Re: Lawrence Recreation Center – Change Order Request No. 1, 3 and 4.

As discussed in our meeting today I recommend approval of the following Change Orders on the Lawrence Recreation Center at Rock Chalk Park.

# CHANGE ORDER

**Number:** 001

**P101F**  
©2013 HOSS & BROWN ENGINEERS, INC.

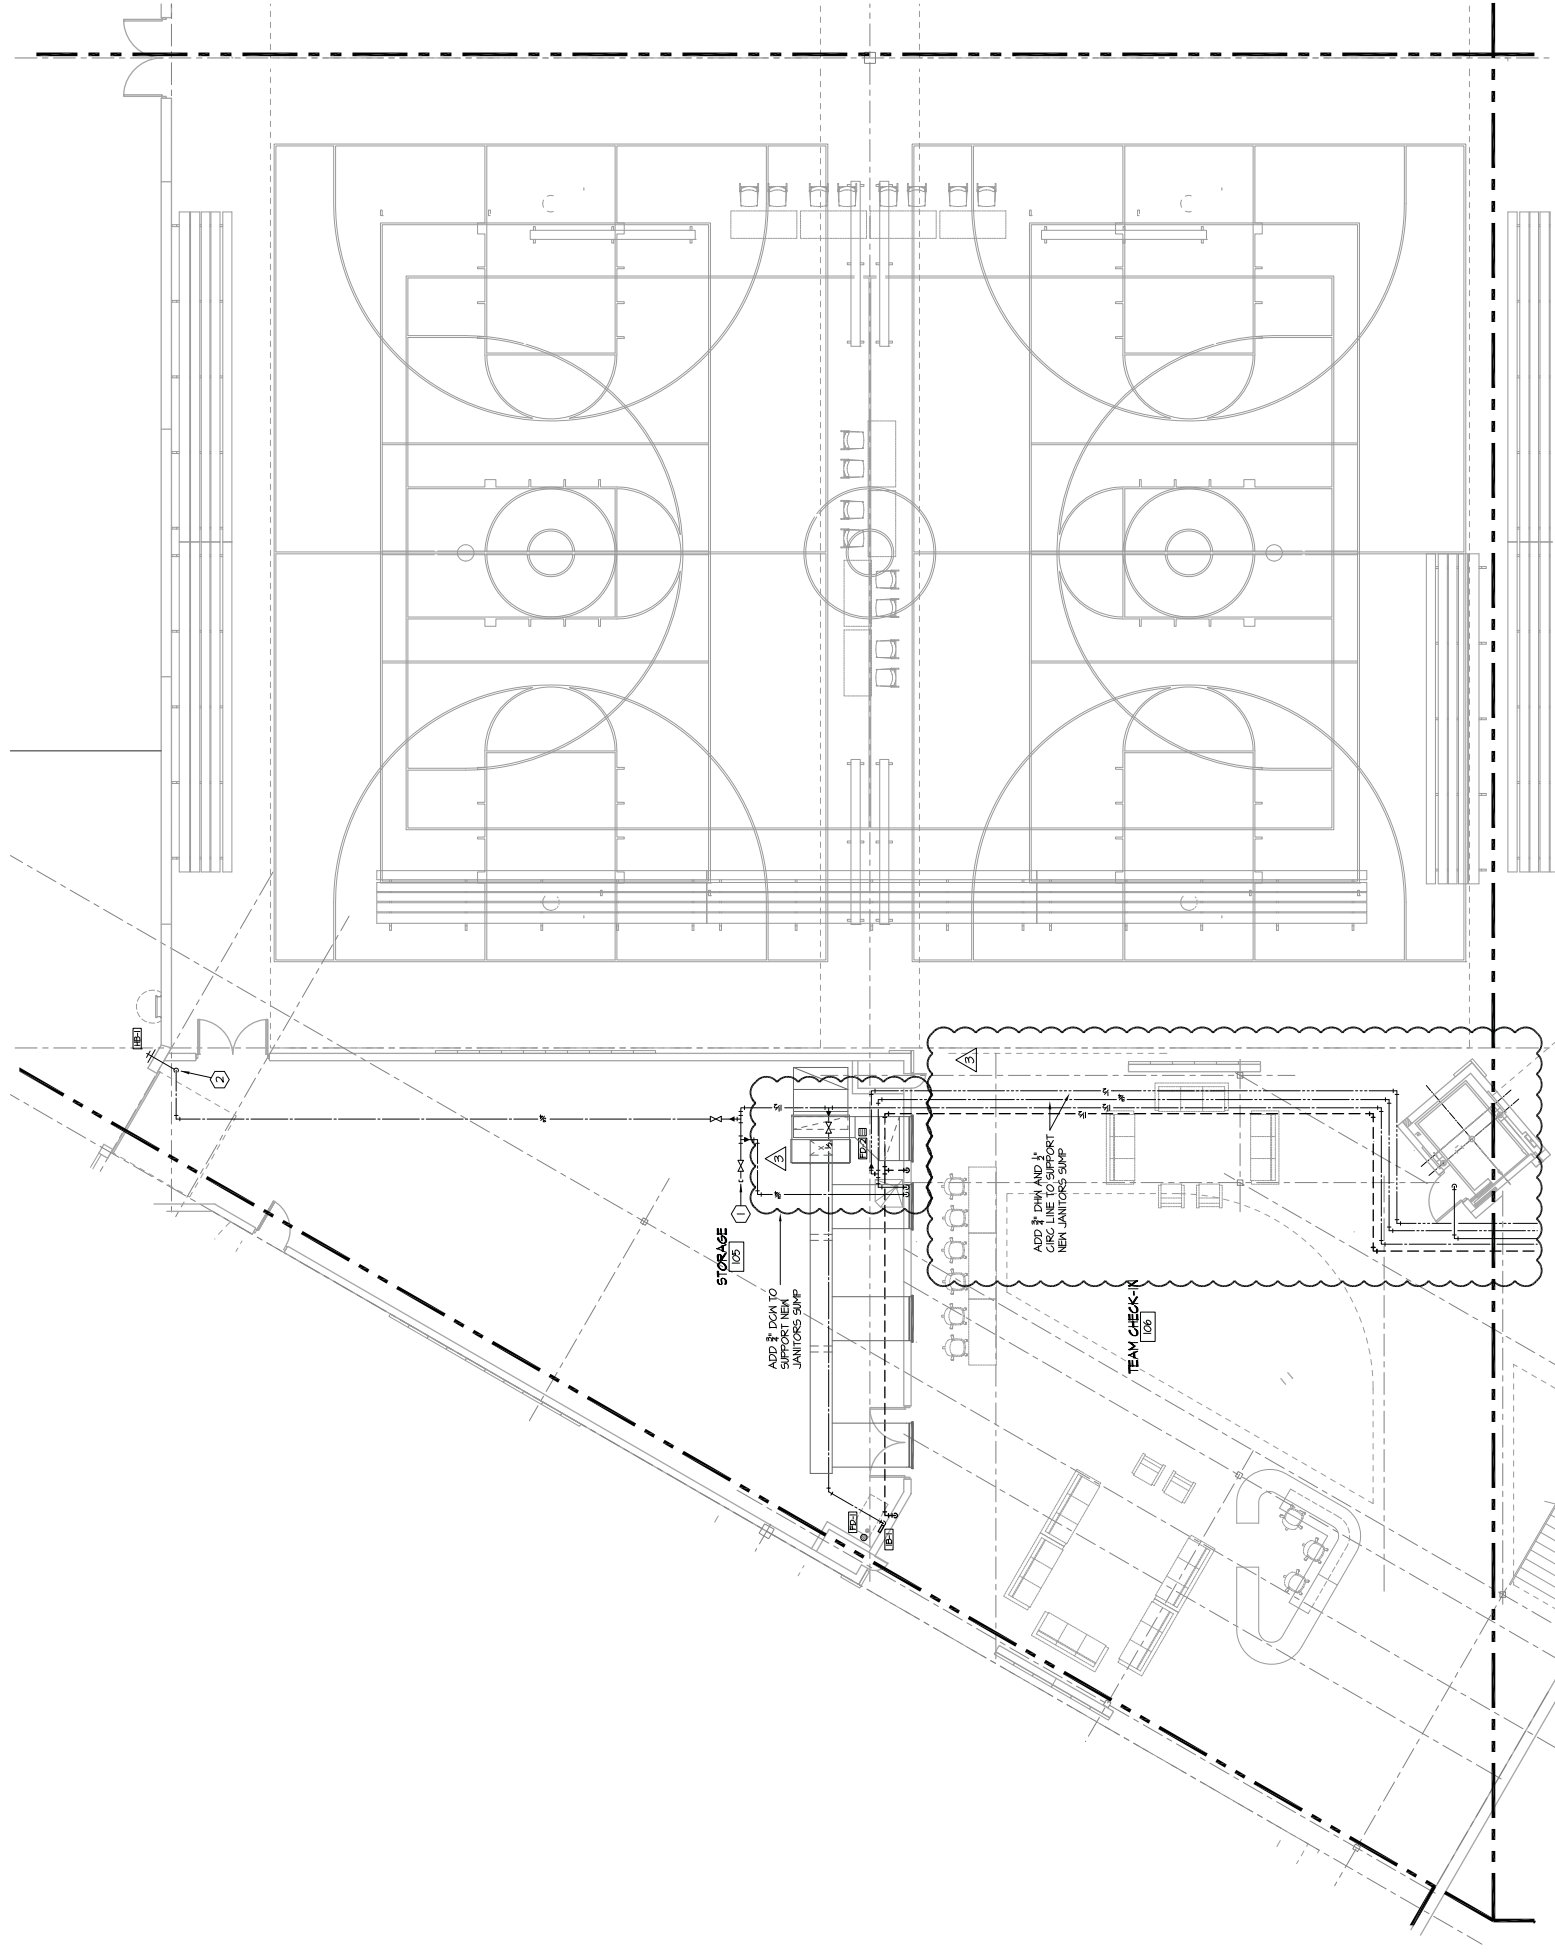
1. Add Janitors Sink per City request	
A. See attached breakdown	\$ 5,468.75
2. GC Margin 5% & OH 5%	\$ 546.88
<b>TOTAL</b>	<b>\$ 6,015.63</b>

BASE BID INCLUDES: install plumbing as per instruction to added Janitors Sink in room 105, remove and replace concrete as needed, Domestic water piping as per plans and instructions, vent piping as per plans, Janitors sump is assumed to be a Mop sink 24X24 stone commercial grade , with faucet and mop hangers, bumper guards

**E101B**  
 ©2013 HOSS & BROWN ENGINEERS, INC.

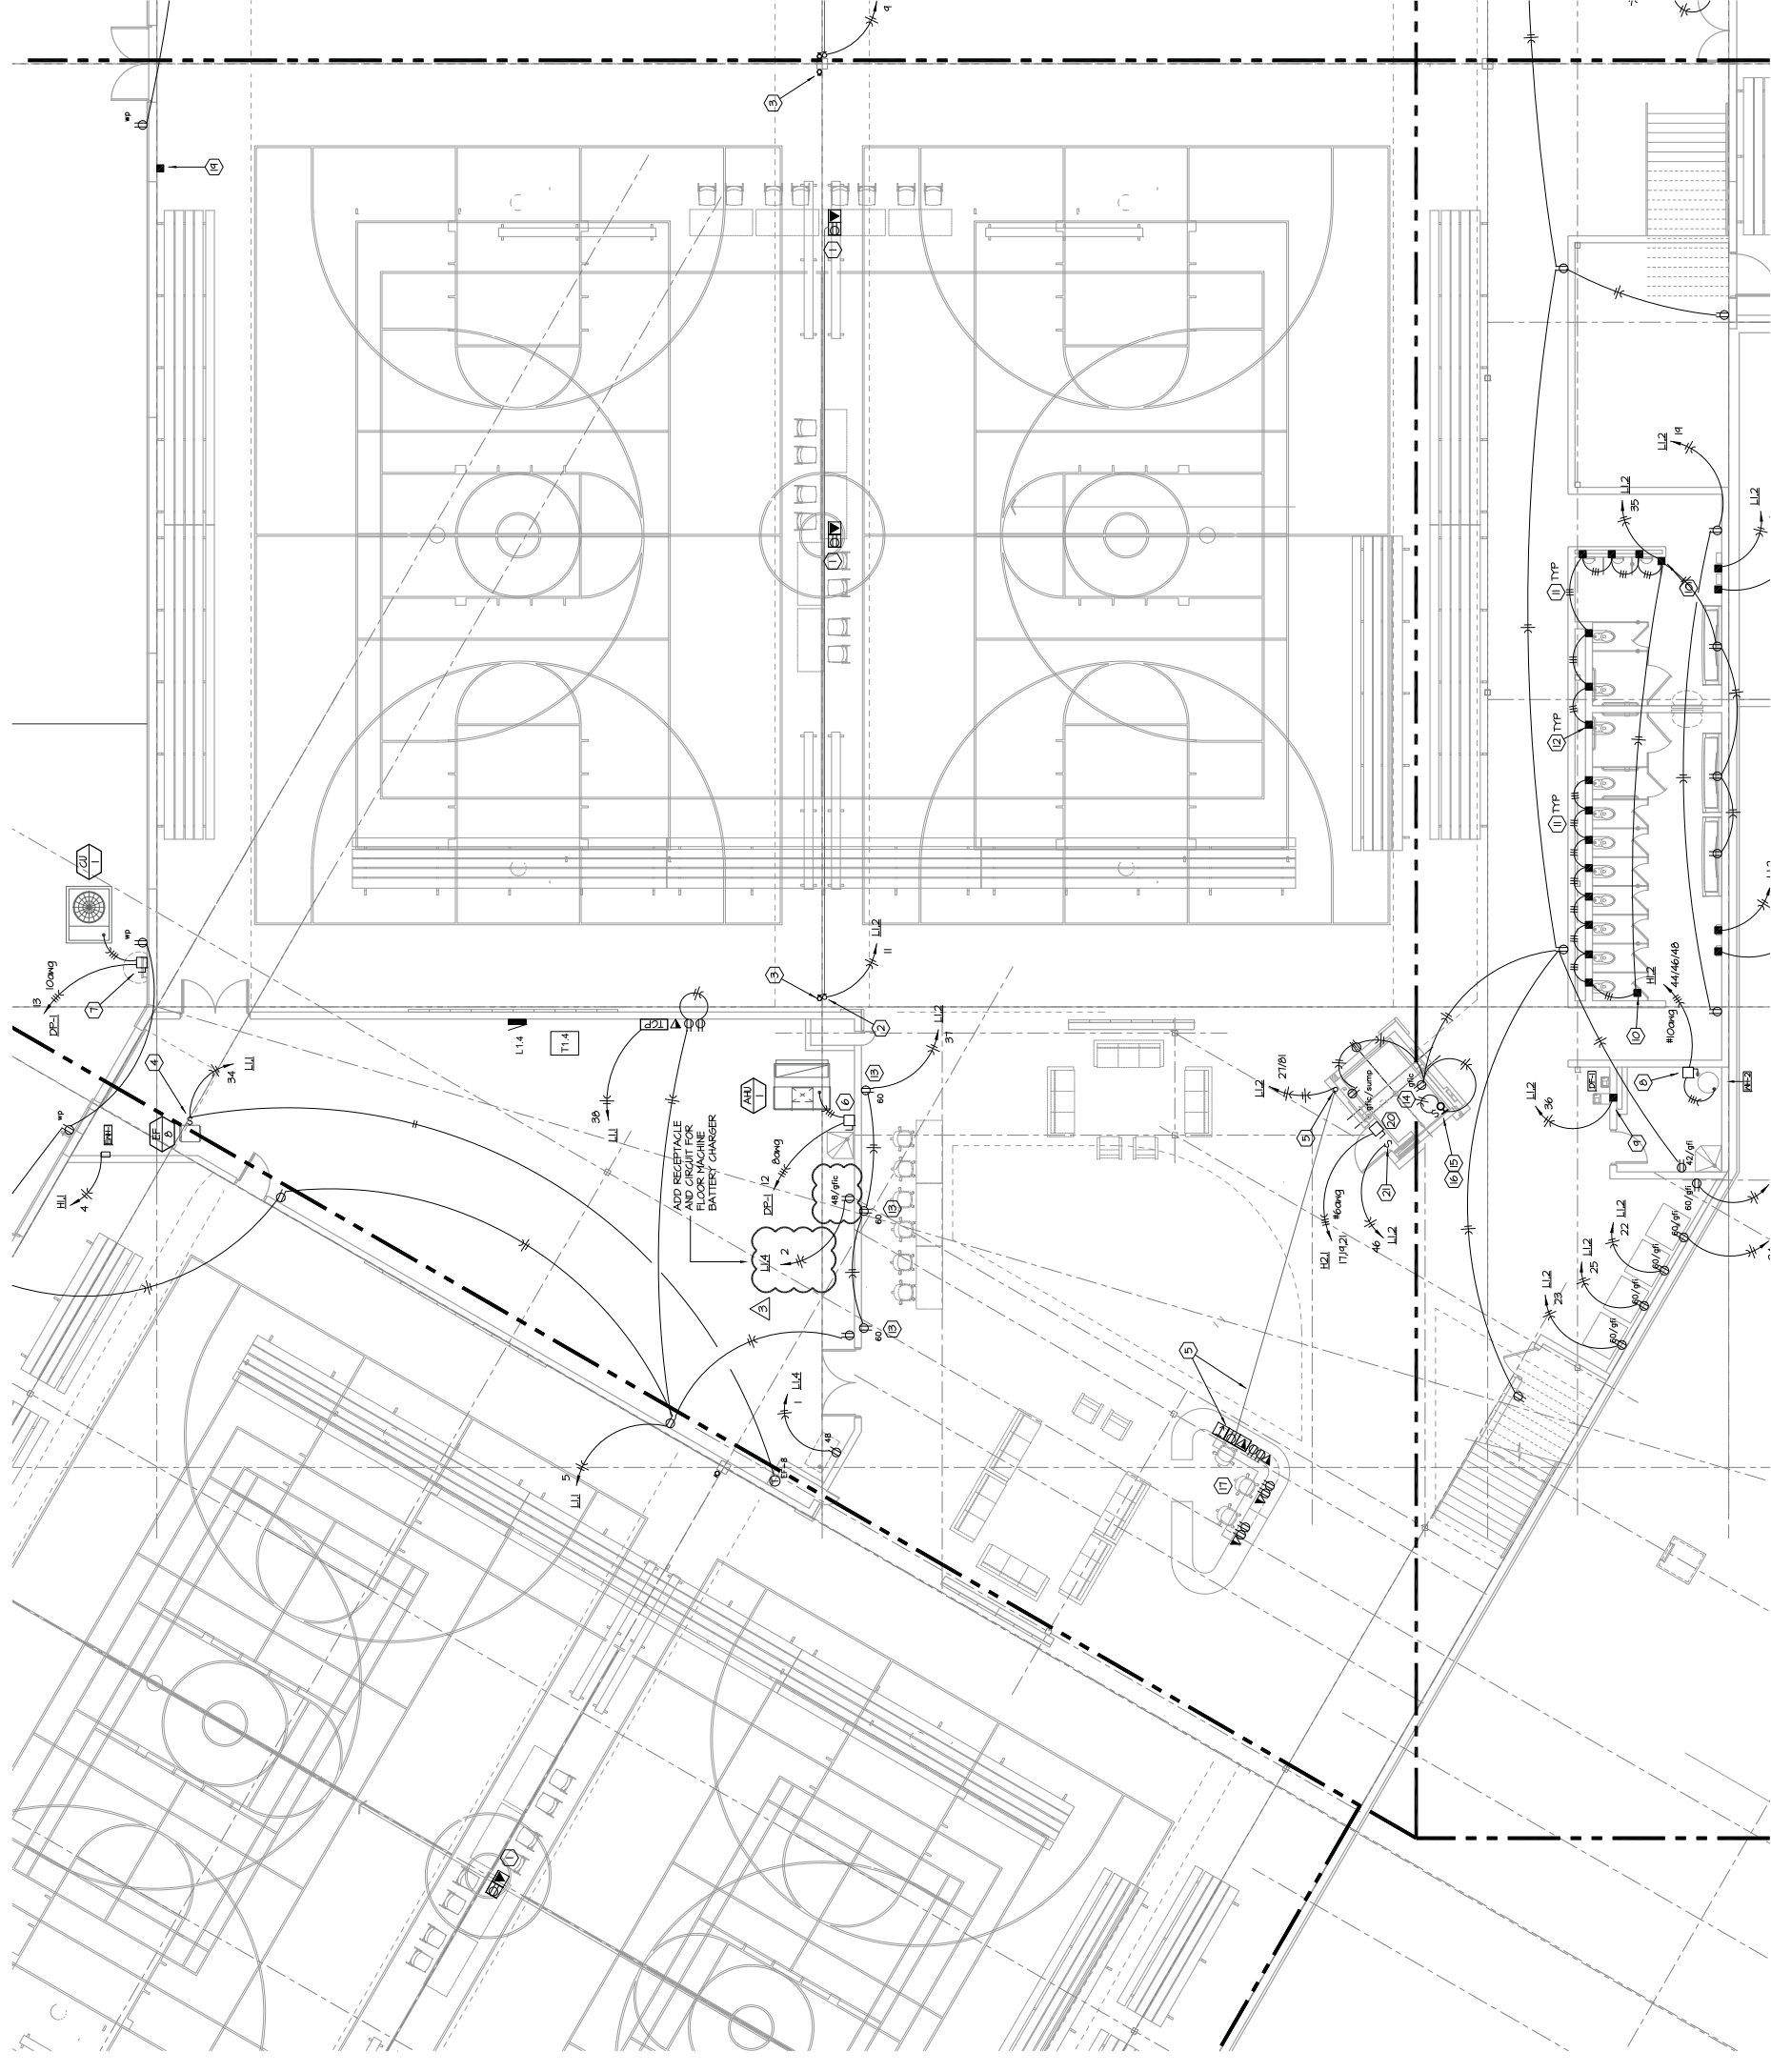
E 102 F		
	(6) 1/20 circuits \$ 250.00 each	\$ 1500.00
	(2) 2/20 circuits \$ 344.00 each	\$ 688.00
E 101 B		\$281.00
	(1)1/20 circuit for floor machine \$ 281.00	
E 101 F		
	(1) add outlet \$120.00	\$ 120.00
E 101G		
	(2) add outlets \$120.00 each	\$ 240.00
	75 ft of surface wire way with 3 outlets.	<u>\$ 719.00</u>
Total		\$3,548.00
